Re: Kagie Gravel Pit, File No. M-1979-102

Response to Technical Revision (TR-3), Adequacy Review #3

## Mining Plan Map Legend:

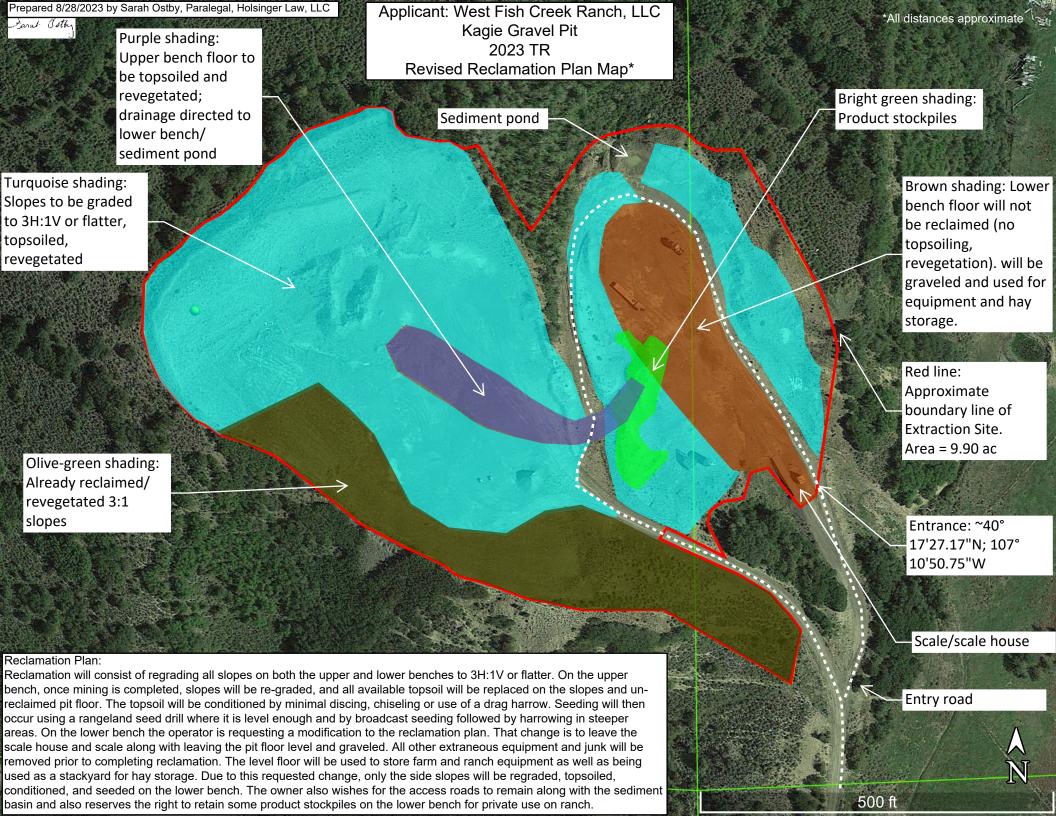
1) The Annual Report Map submitted for 2023 (attached), shows that the total site acreage is 9.9 acres. This map looks to be done by a certified land surveyor. However, the Mining and Reclamation Plan maps submitted with this TR show a total permitted acreage of 9.6 acres. Please elaborate on the methodology used to determine the permitted acreage on maps submitted for these adequacy reviews. If measurements have not been completed by a certified land surveyor, the Division will assume that 9.9 acres is the total permitted area and revised Mining and Reclamation Plan maps will need to be submitted.

**Response:** Revised Mining and Reclamation Plan Maps are attached reflecting the change to 9.9 total permitted acres. Google Earth has been utilized to prepare the Mining and Reclamation Plan Maps and to estimate the permitted acreage.
